GULMOHAR RESIDENCY

Details of Additions & Alterations

Flat No	101 102	Block no.	A F
Flat Area	1360 sft	Type	Deluxe / Luxury
Buyer Name	Sreeram Neeraja .		
Phone No.	8179839614	Email

Description	Direction	Owners & Developers :	Date :	Promoted by
A-BLOCK-FLAT NO 4-SPLIT WORKING PLAN-1360 sft		Modi Reality Mallapur LLP Project Name & Phase : Gulmohar Residency	Prepared By : Jayapratha Approved By : Soham Modi Scale : N.T.S	01.06.2020 Modi Properties Pvt Ltd Phone: +91-40-66335551

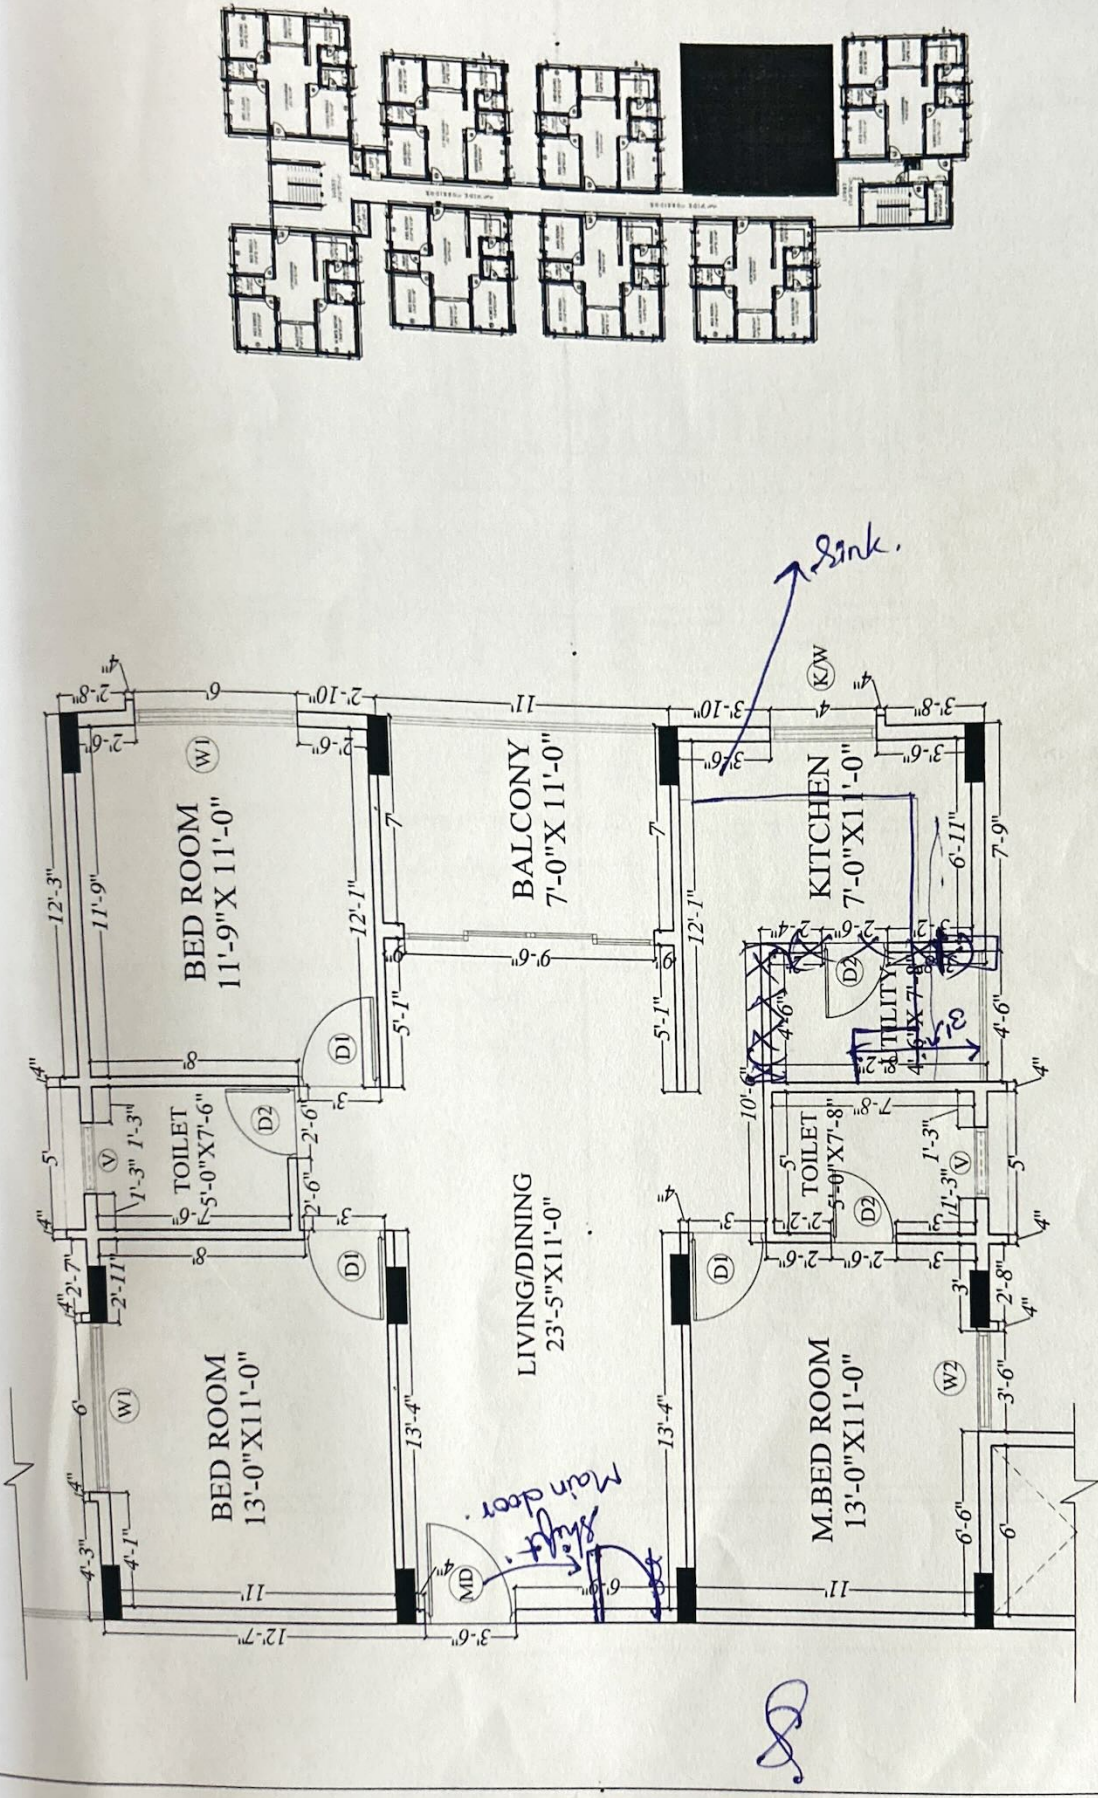
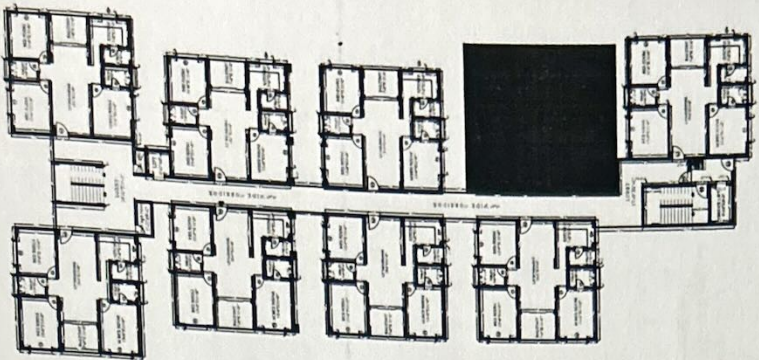
- ① Remove utility room & make as p-shocan in plan.
- ② customer goes to modular kitchen.

Description	Direction	Owners & Developers :	Date :	Promoted by
A-BLOCK-ELECTRICAL PLAN -1360 sft FLATS-A2 TYPE	N	Modi Reality Mallapur LLP	21 09 2020	Modi Properties Pvt Ltd
		Project Name & Phase :	Prepared By :	
		Gulmohar Residency	Approved By :	
			Scale :	
				Phone: +91-40-66335551

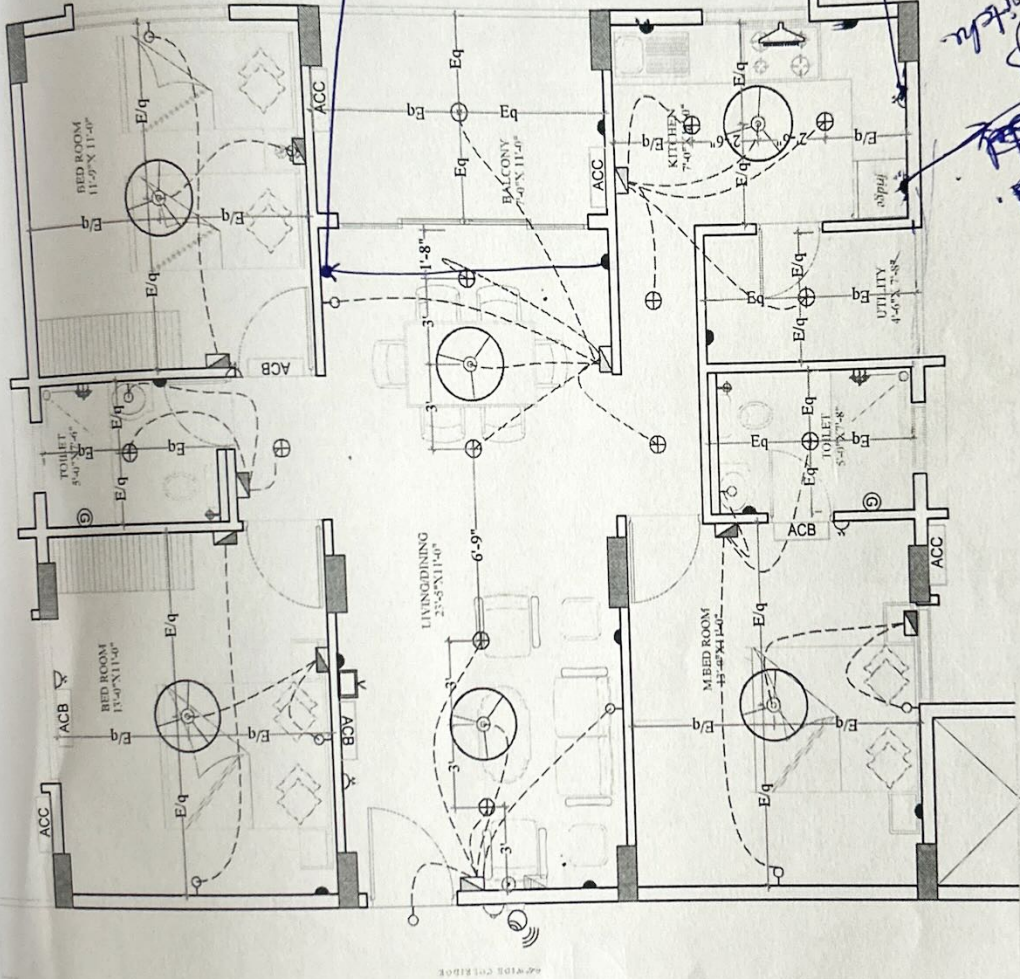
① Extra Electrical point in kitchen.

Description BLOCK-A-FLAT NO 101-PLUMBING PLAN(A2-TYPE)	Direction	Owners & Developers :	Date :	Promoted by
		Modi Reality Mallapur LLP	Prepared By :	16.09.20
		Project Name & Phase :	Approved By :	Jayapradha
		Gulmohar Residency		Soham Modi
				Scale :
				Phone: +91-40-66335551

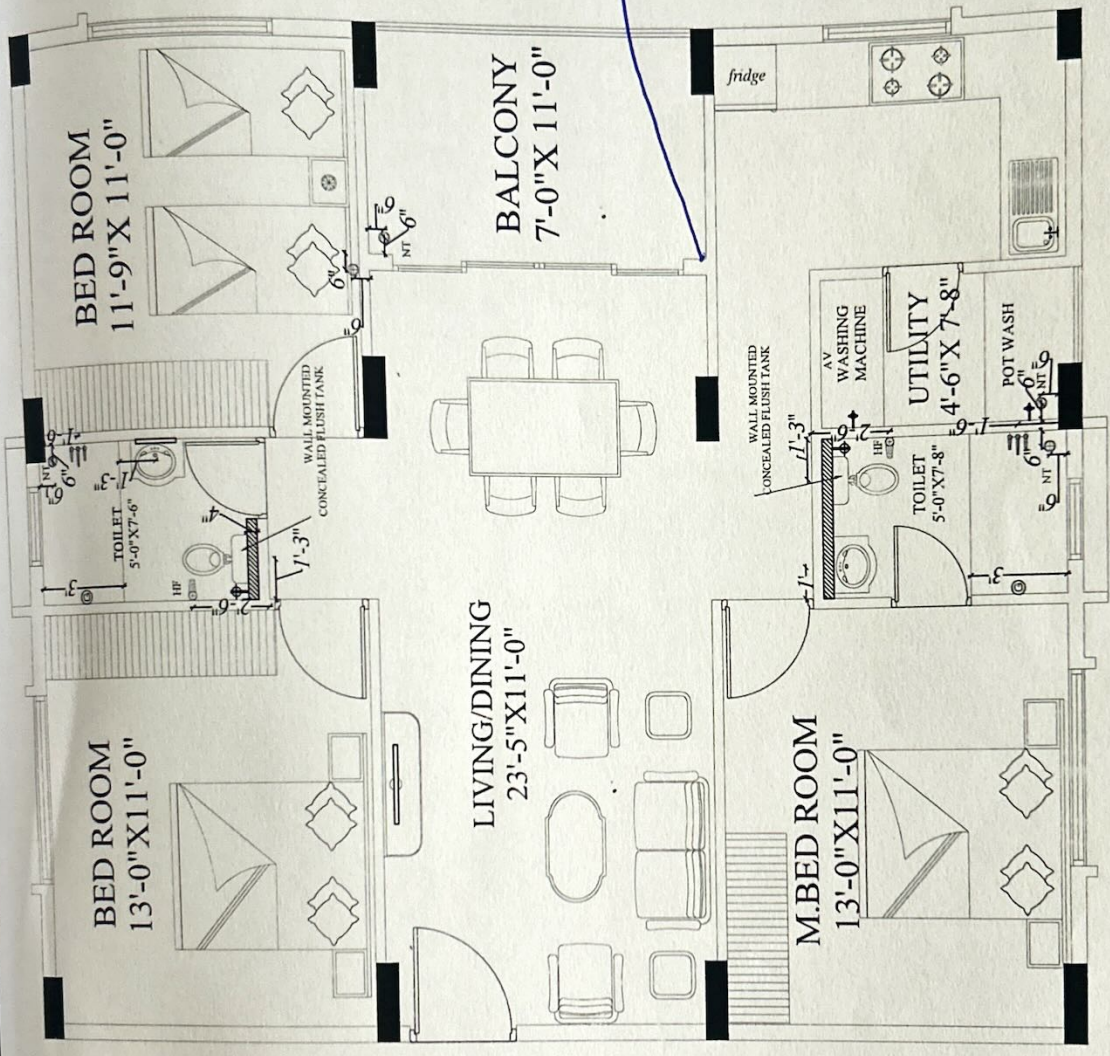
- ① Sink Was Customer Provided with own cost
- ② ~~Extra in Bal Cony~~ Removed Wash Basin

extra wash basin
Required
